STATE OF VERMONT
AGENCY OF TRANSPORTATION

PROPOSED IMPROVEMENT
BRIDGE PROJECT

TOWN OF RIPTON
COUNTY OF ADDISON

RECORD PLANS

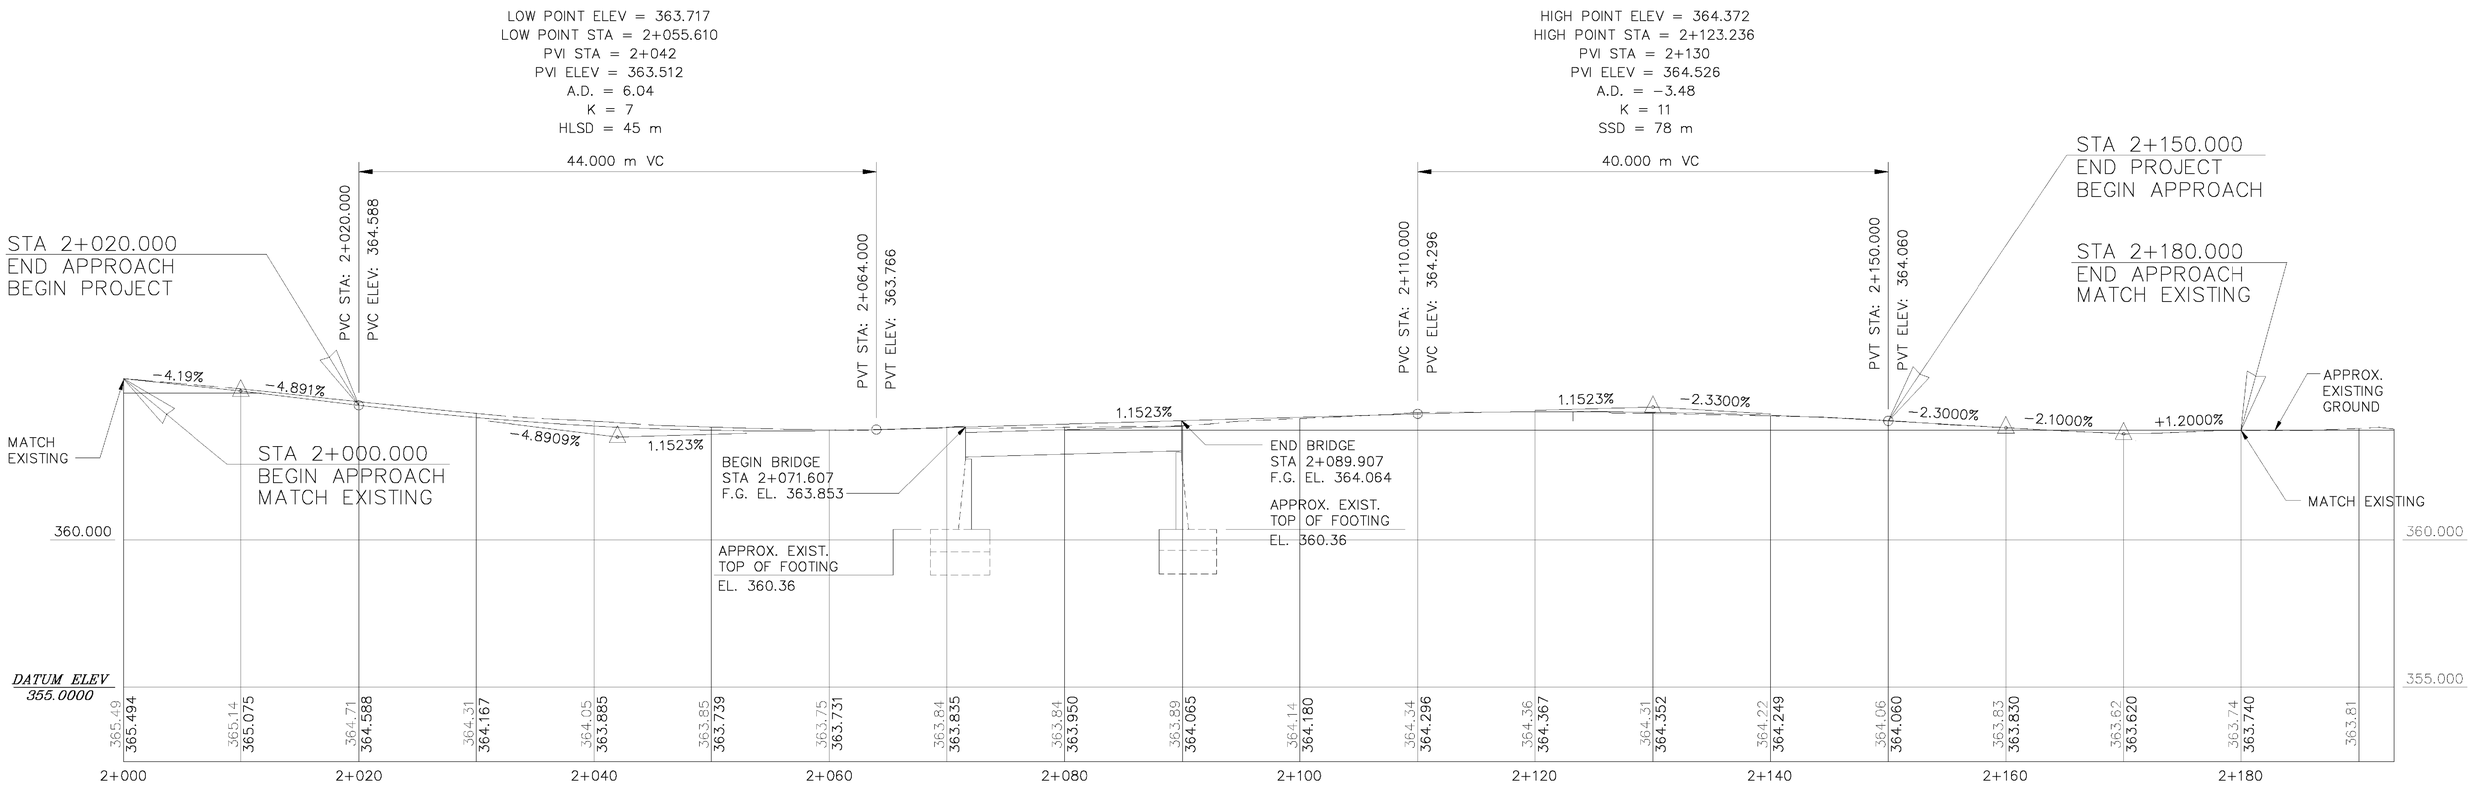
REVISED BEGIN APPROACH GRADE AND EXISTING ELEVATIONS.

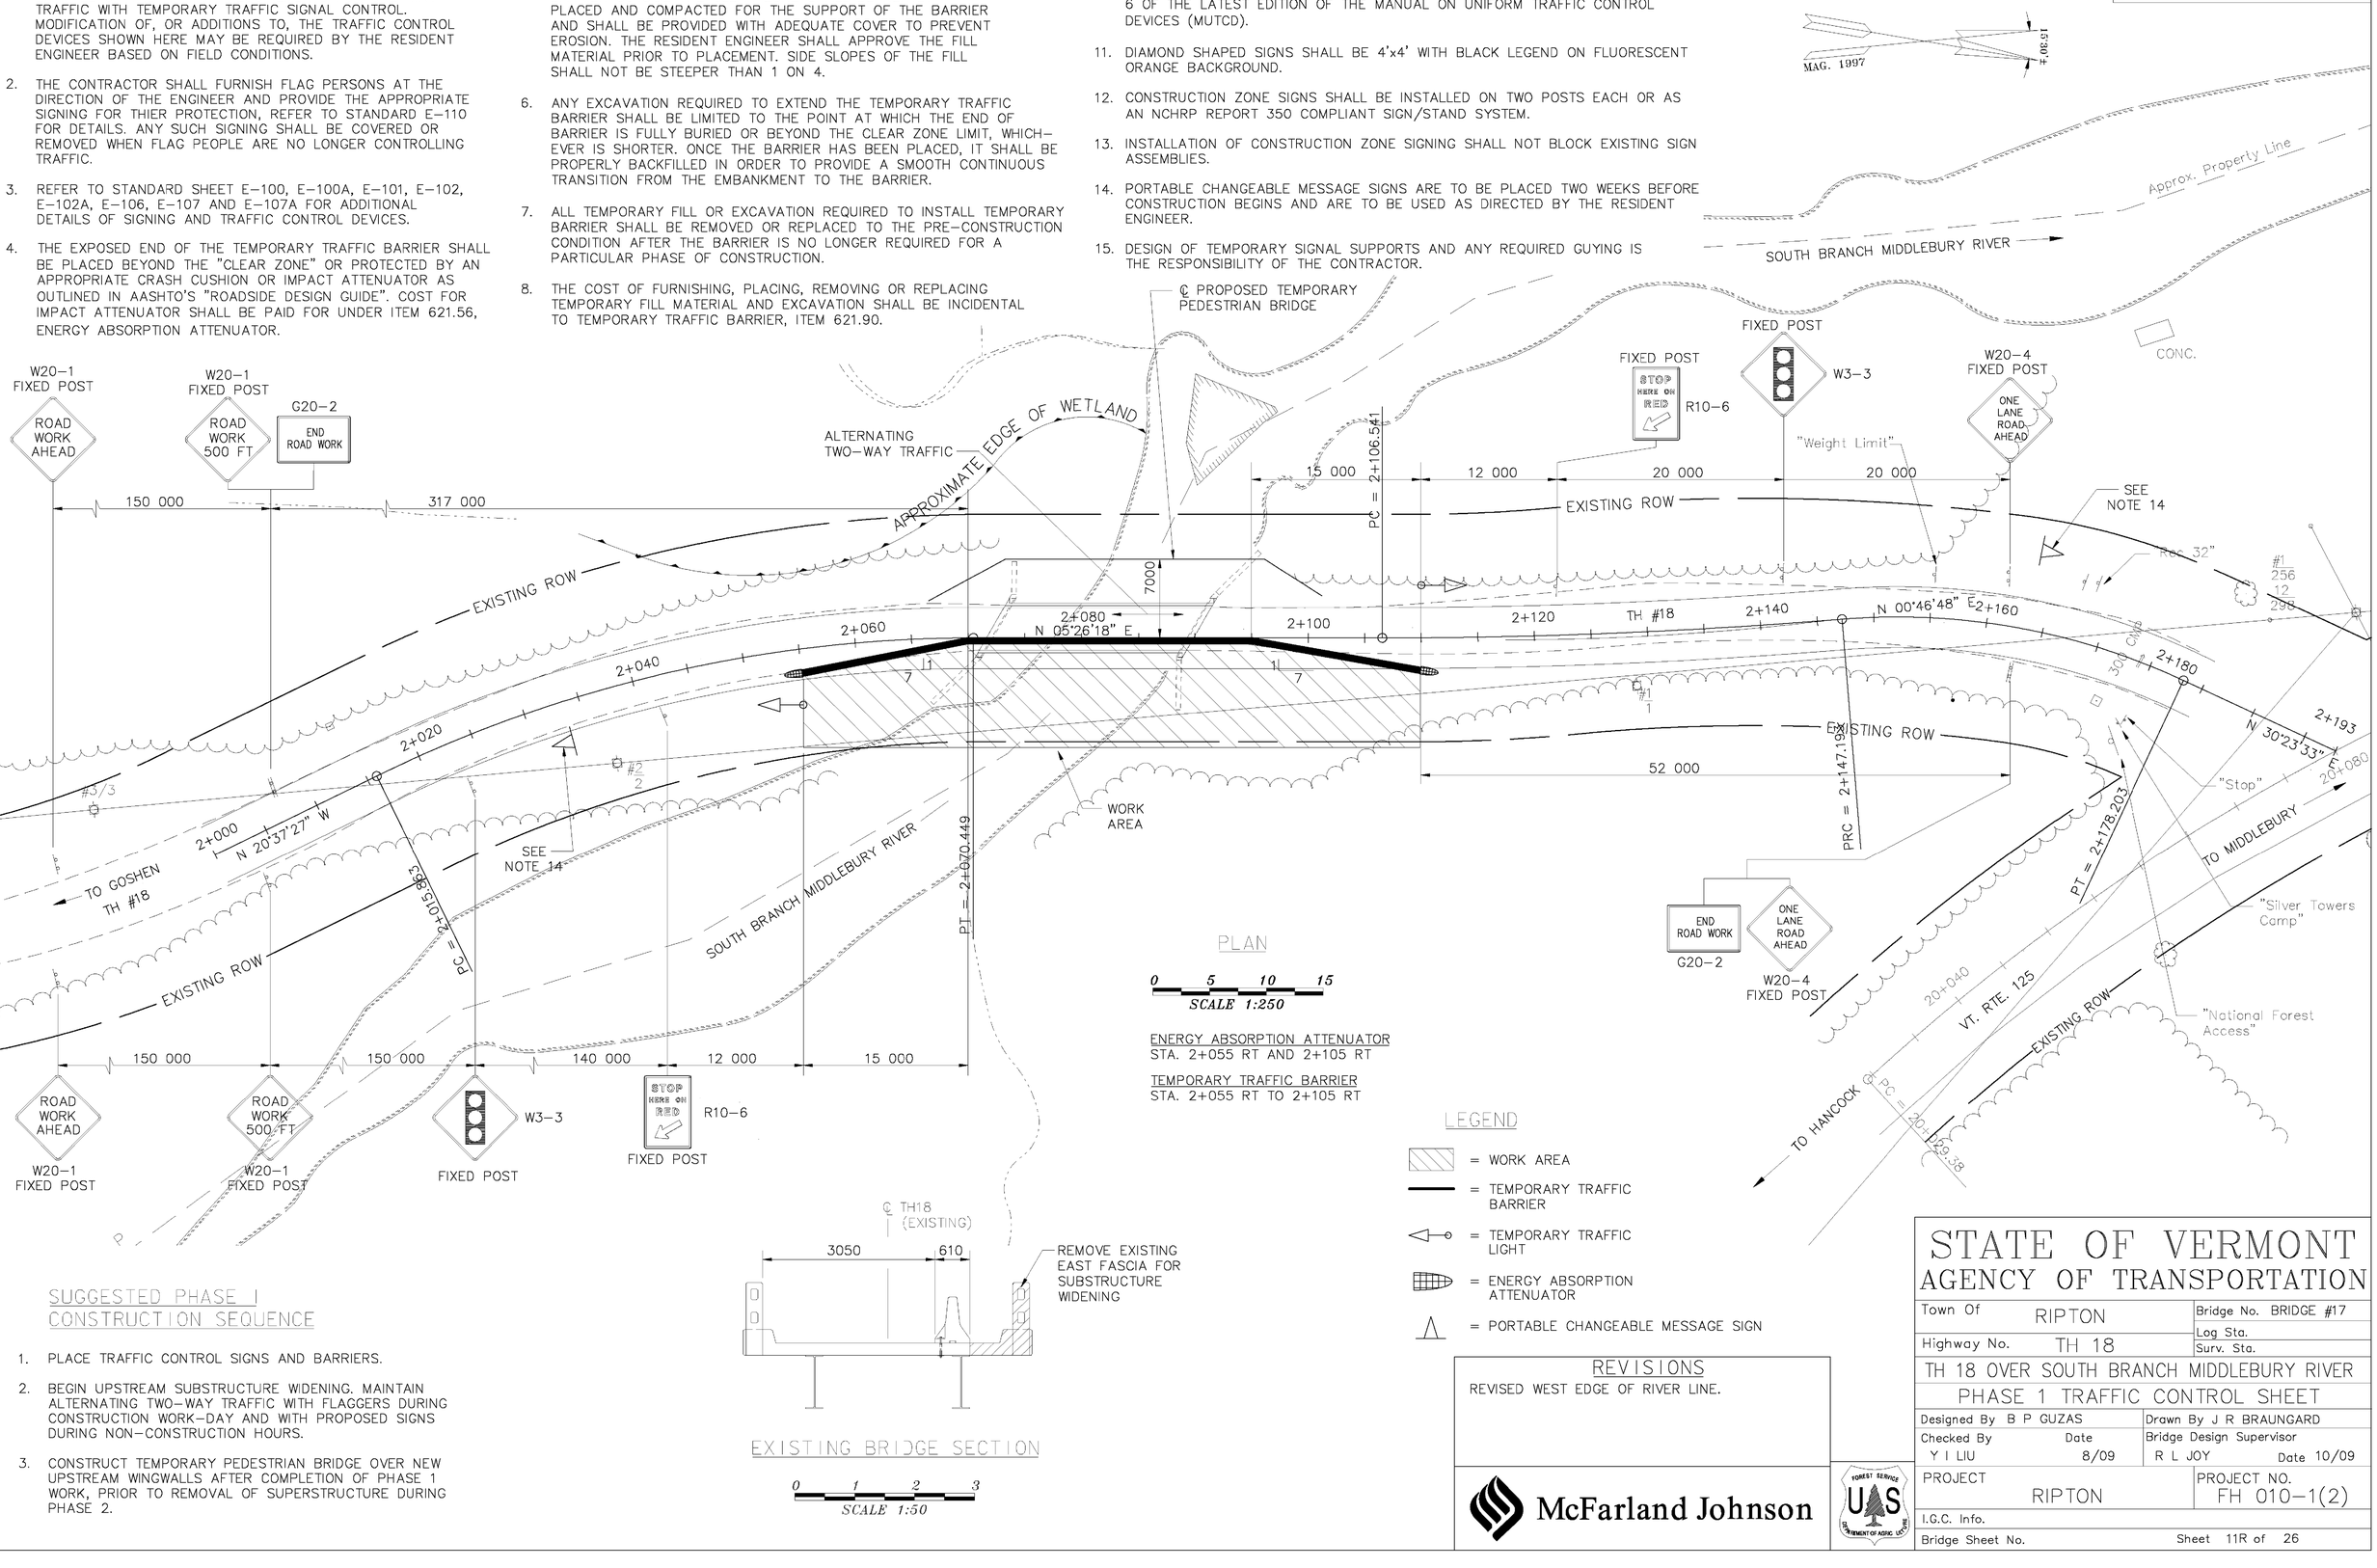
REVISED WEST EDGE OF RIVER LINE.

Designed By B P GUZAS	Drawn By W J GAYNOR
Checked By Y I LIU — Date 8/09	Bridge Design Supervisor R L JOY — Date 10/09
PROJECT RIPTON	PROJECT NO. FH 010–1(2)
I.G.C. Info.	
Bridge Sheet No.	Sheet 12R of 26

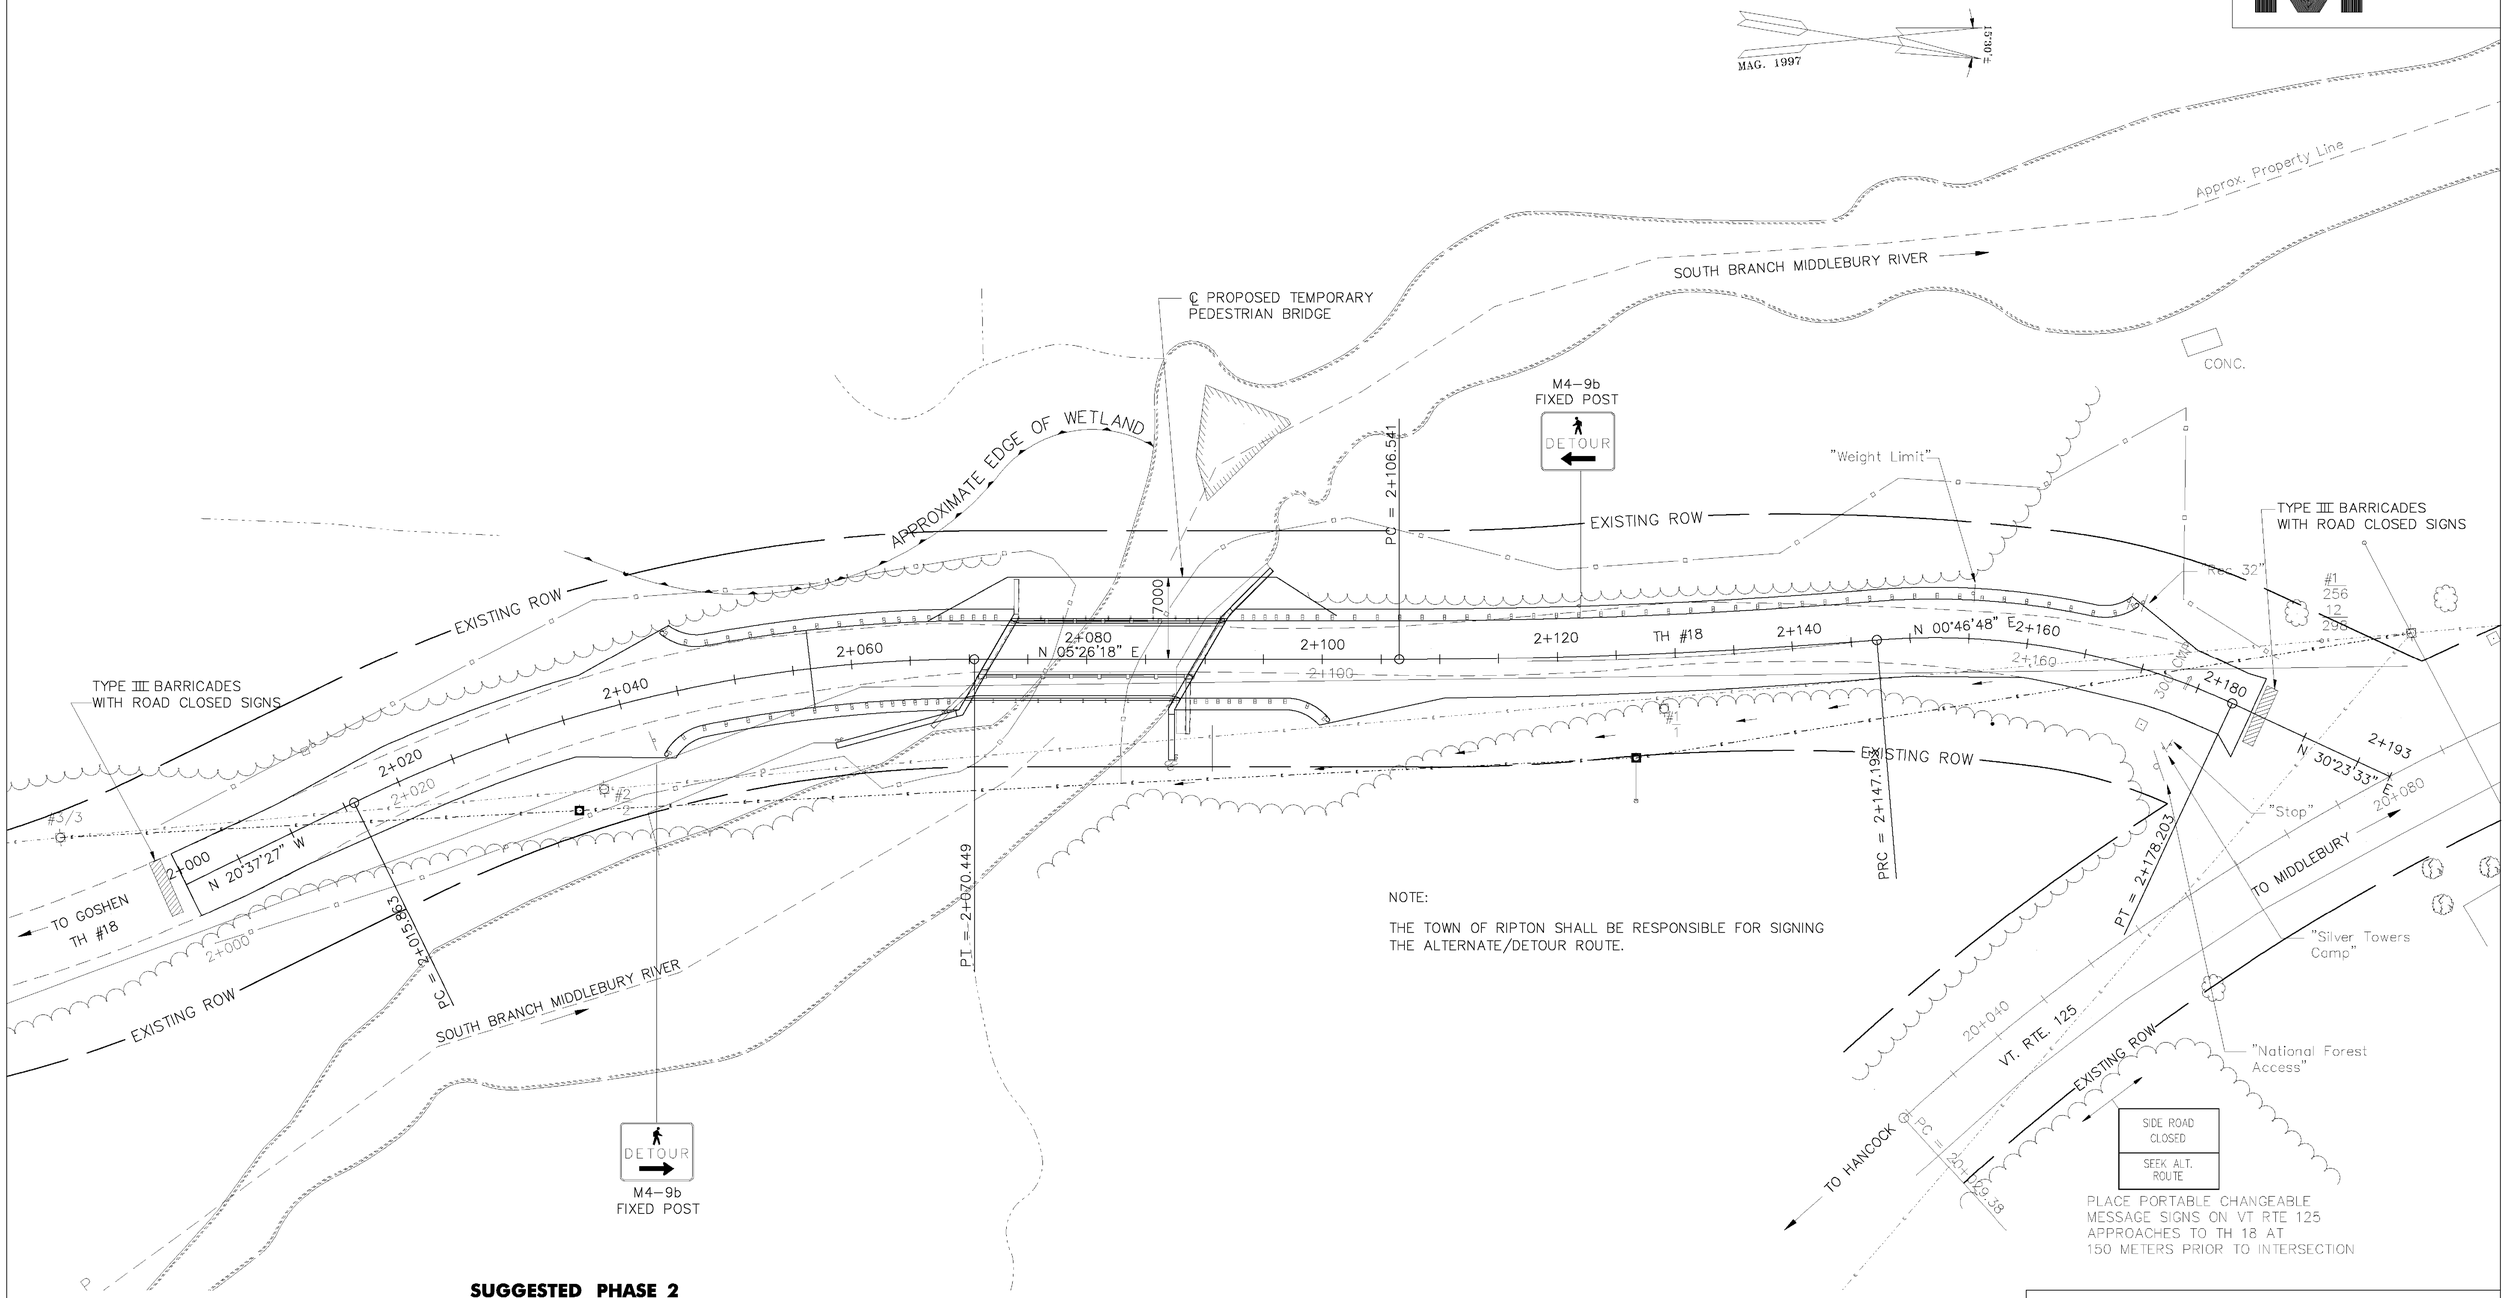
REVISED WEST EDGE OF RIVER LINE.
REVISED WINGWALL 2.

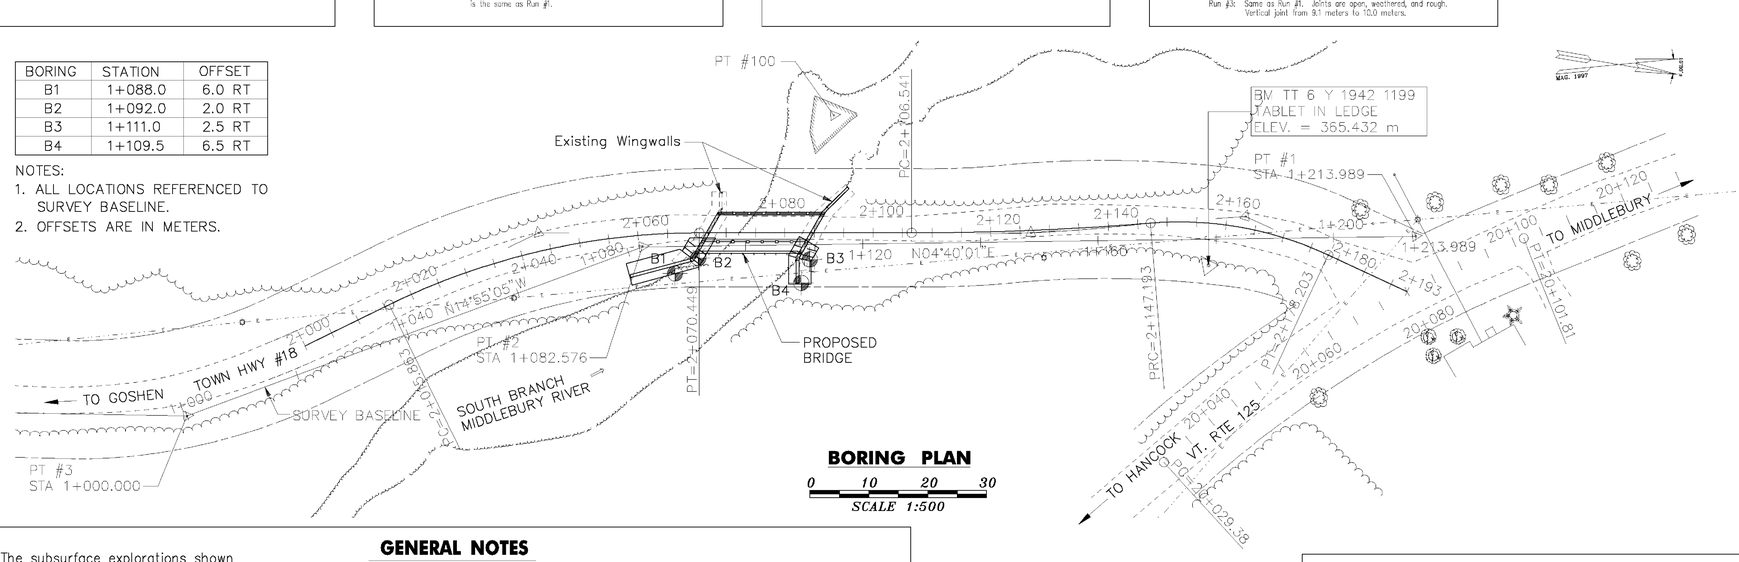
REVISED WEST EDGE OF RIVER LINE.
REVISED WINGWALL 2

ELEVATION

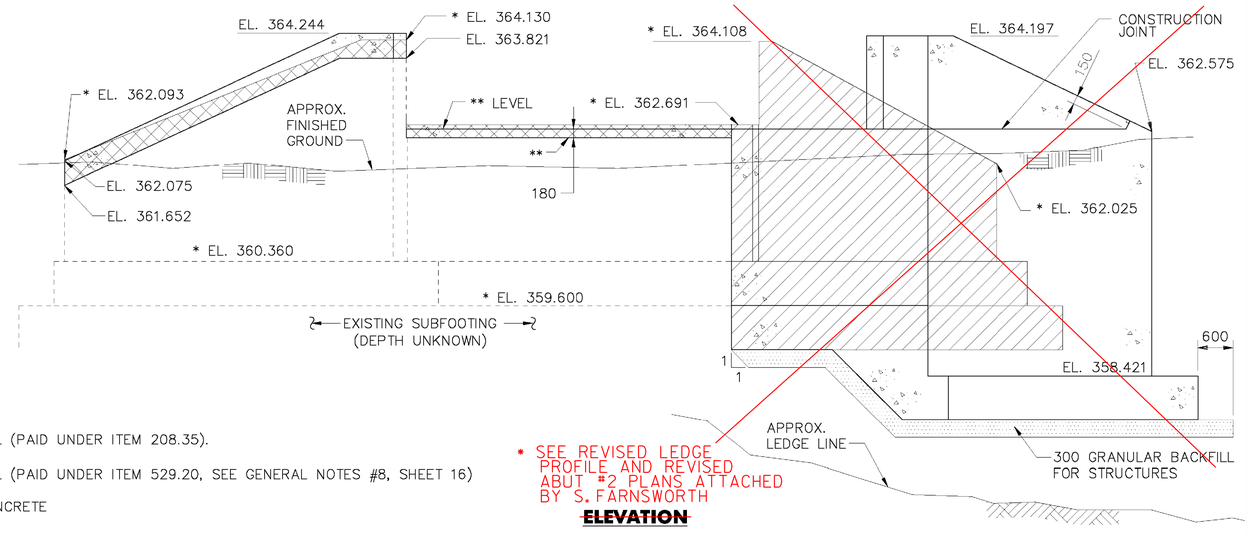
* SEE REVISED LEDGE PROFILE AND REVISED ABUT #2 PLANS ATTACHED BY S. FARNSWORTH

REVISED ABUTMENT #2 SECTION
SCALE: 1:50

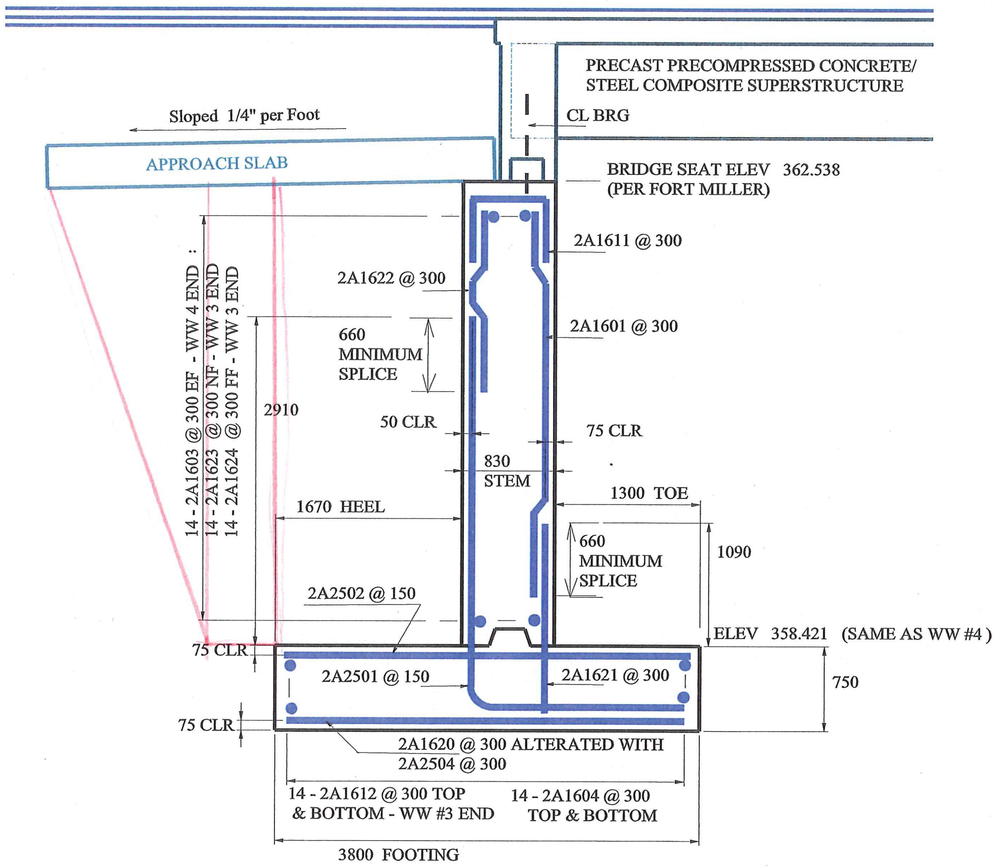
1. REBAR MARK "A1606 @ 300" SHALL BE DRILLED AND GROUTED INTO WINGWALL #3 AT LEFT END OF ABUTMENT AS CALLED FOR IN OCT 2009 PLANS SHEET 20R OF 26.
2. AFTER THE SUPERSTRUCTURE IS SET THE TWO PRECAST APPROACH SLABS SHALL BE SET WITH THE 25 mm GAP AND THEN HOLES DRILLED INTO THE ABUTMENT STEM FOR THE 600 mm REBAR.
